CITY OF ALBUQUERQUE

RE: Lot 15 Block 4 Unit 22 Volcano Cliffs SAD 228 6423 Canavio St NW Grading and Drainage Plan Engineers Stamp Date 4/27/17 (D10D003D15)

Based upon the information provided in your submittal received 5/9/17, this plan is approved for Grading Permit. <u>Prior to building permit approval the following</u> comments must be addressed.

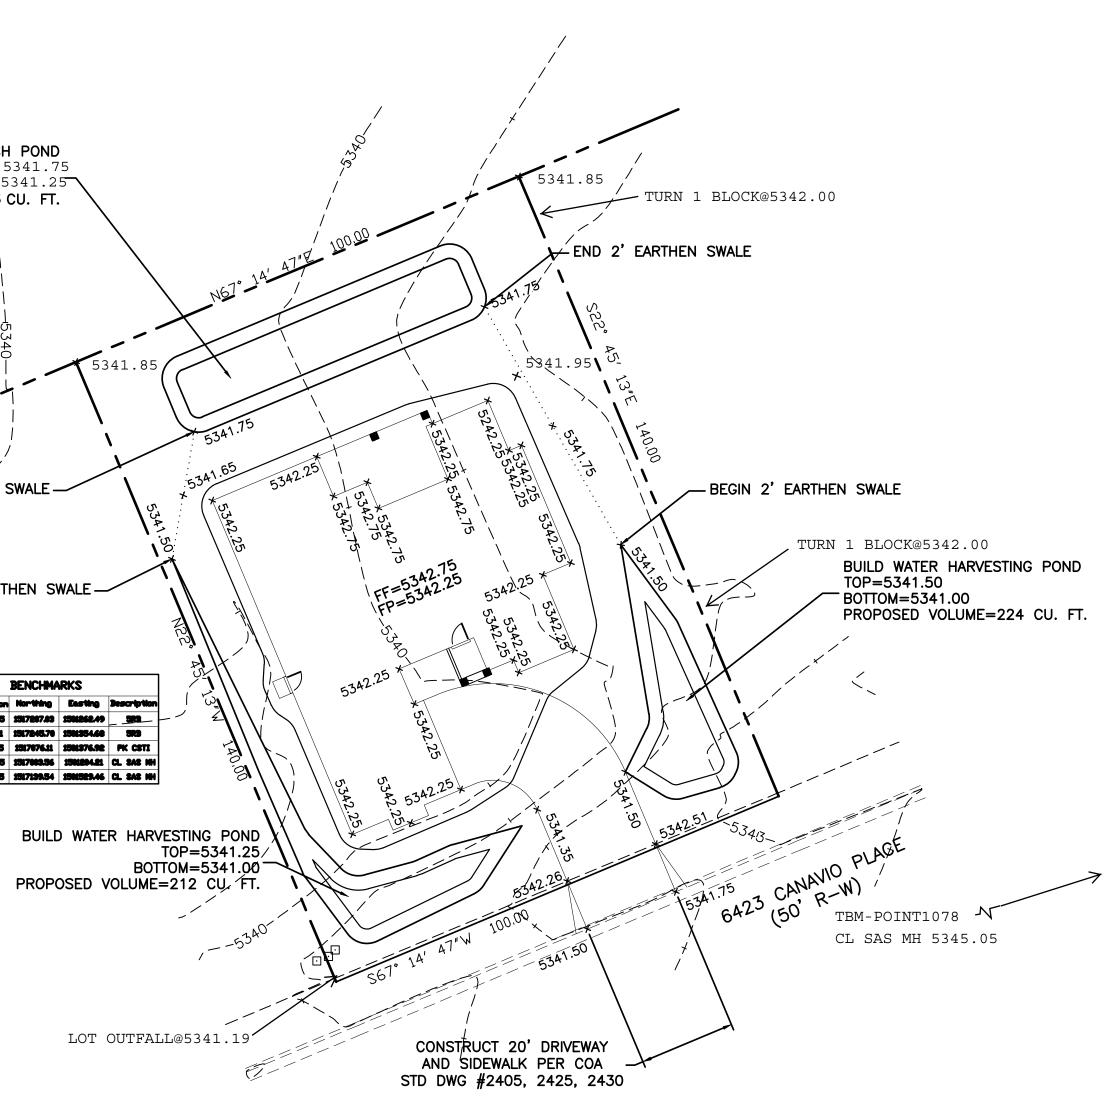
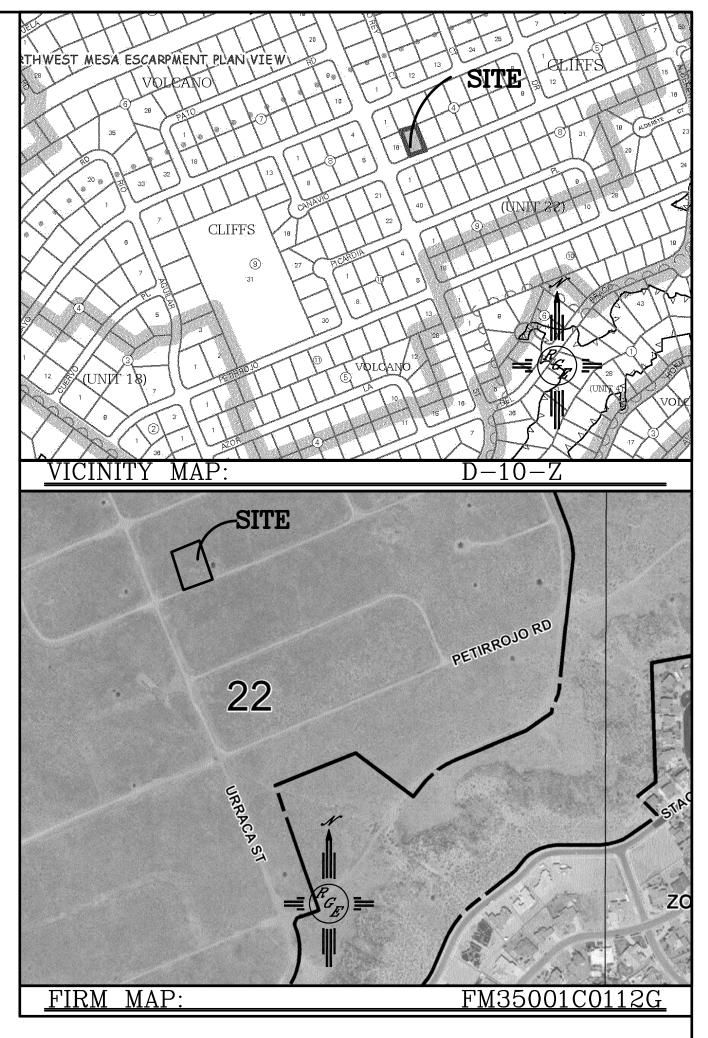
- Provide a pad certification.
- Provide an opening at the NW corner of the property, 3" above grade.

Owner/Contractor that a separate permit for a garden/retaining wall must be obtained, with the approved G&D plan dated 4/27/17. Prior to Certificate of Occupancy release, Engineer Certification per the DPM checklist of
